TECH ADVISORY for
SFI Specification 2.3N
Rear Engine Dragster Roll Cage (Top Fuel); 6.29 Seconds E.T. & Quicker
Effective: February 18, 2009

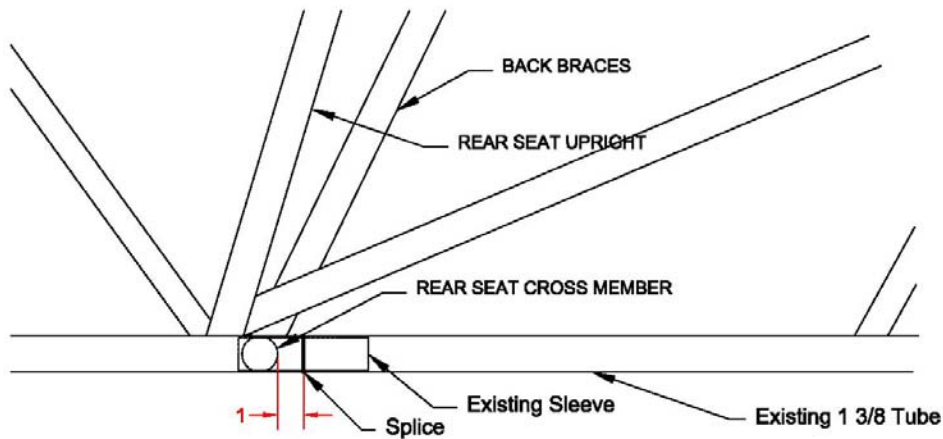
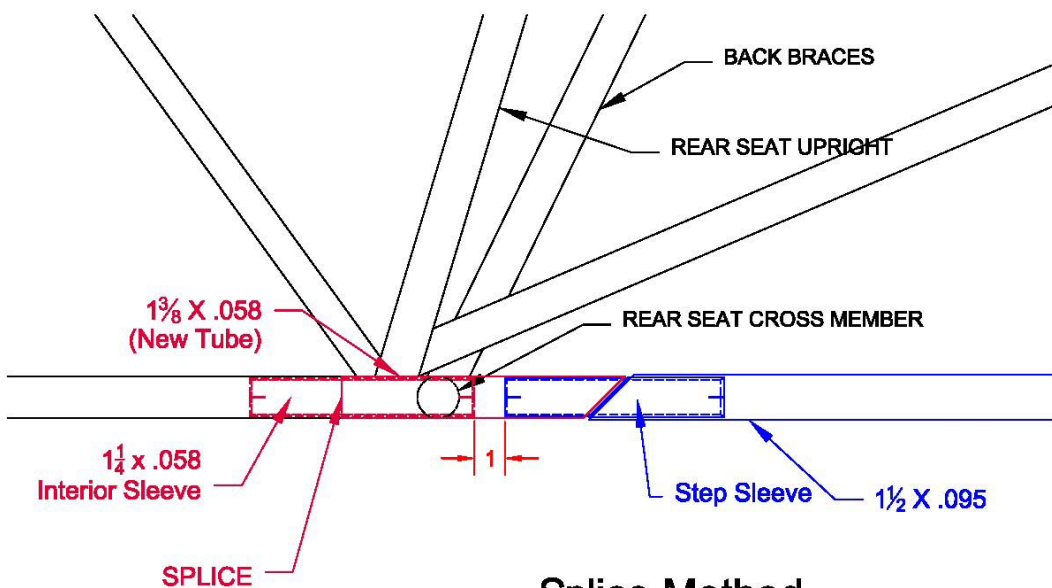
When a car cannot meet the original back half attachment criteria for a bottom splice joint, the bottom frame rail may be spliced forward of the rear seat upright per the below drawing. An interior sleeve machined to match the ID of the parent tube and have a minimum of .058" wall thickness, must extend a minimum of 3" on each side of the splice, and/or past the seat upright and rear seat cross member, whichever is greater. There shall be a minimum of 1" between the end of the interior sleeve in the cockpit and the end of the interior step sleeve from the back half. All standard construction practices and existing 2.3N specifications shall apply to the interior sleeves and splice joint.

Typical Splice too close to Seat Upright and/or Crossmember

Splice Method
